EARLY DESIGN GUIDANCE OF THE EAST DESIGN REVIEW BOARD

Project Number: 3012300

Address: 505 11th Ave E

Date of Meeting: Wednesday, August 17, 2011

The fourth scheme (Option 4) was the preferred scheme and showed 24 units in three buildings.

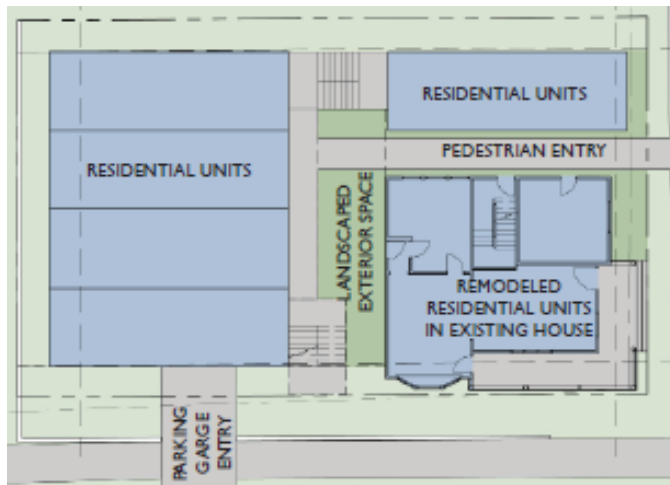
- Opposed to the location of a four story building at the north property line, because of the rhythm of the buildings at 11th Ave E and the shadow/bulk impacts on the neighbor to the north

- The preferred design showing additions on two sides of the existing structure looks very cramped and out of character with nearby development.
- Support for considerate design to the Park, but the bigger need is considerate design on the sides facing the neighborhood.

The Board directed the applicant to modify the design to reflect this rhythm along 11th Ave E. A departure from the east property line setback might be justifiable, but the design should include large massing breaks at the north and south property lines. One way to achieve this is to place the existing structure at the east property line, but not add new structures to the north or south of it. It is also possible to achieve this by demolishing the existing structures and building new structures to respond to this street pattern.

At the Early Design Guidance Meeting, the Board expressed concern with the departures proposed at the north and west property lines, and the building mass proposed at the north property line. The Board stated that the proposal should be modified to meet Land

Use Code requirements at the west and north property lines. Departures from the internal setbacks between buildings, the east property line setback, and the south property line setback could be considered.

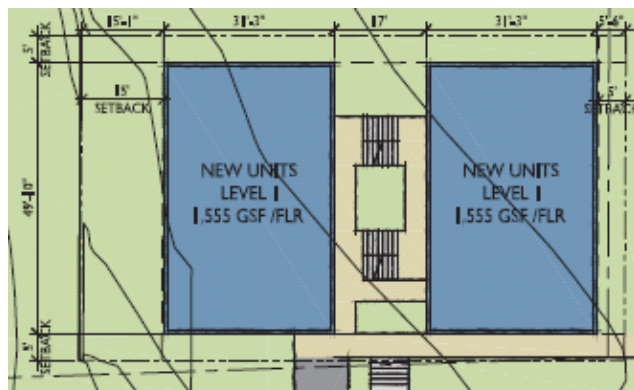
At the Second Early Design Guidance Meeting, the Board reiterated the earlier guidance, with the addition of other possible methods to reduce the appearance of bulk at the west façade. The Board noted that Option A does not appear to meet the earlier guidance, and they would be less inclined to recommend departures based on the design as shown. However, reduction in bulk at the west façade may be possible through methods such as removing the parking, further setting back the upper story from the west property line, modulation and articulation, roof forms, reduction in building width, and façade treatment. Façade treatment could include finely scaled materials, sunshades, fenestration, and other methods in context with nearby development. If the resulting proposed design better met the intent of the Design Review Guidelines, it is possible that the Board could recommend the proposed departures.

The Board expressed concern with this proposed departure, and indicated they would be unlikely to consider a departure from the west property line as shown in Option A. However, a departure could be supportable if the applicant demonstrated the proposed design better meets the intent of the design review guidelines as described in the guidance for Guideline A-1.

The Board expressed concern with this proposed departure, and indicated they would be unlikely to consider a departure from the west property line as shown in Option A. However, a departure could be supportable if the applicant demonstrated the proposed design better meets the intent of the design review guidelines as described in the guidance for Guidelines A-1 and A-2.

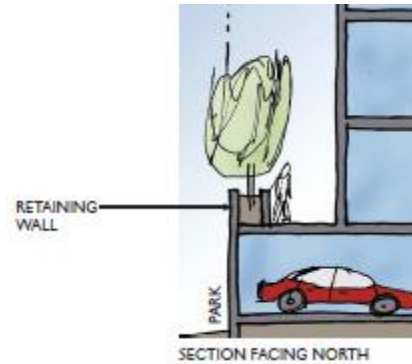
Shadow studies presented at the second EDG meeting demonstrated shadow impacts to the Park and the properties to the north. The applicant also provided an area-wide plan view graphic, showing the location of building masses on site in nearby streets, compared with the proposed massing.
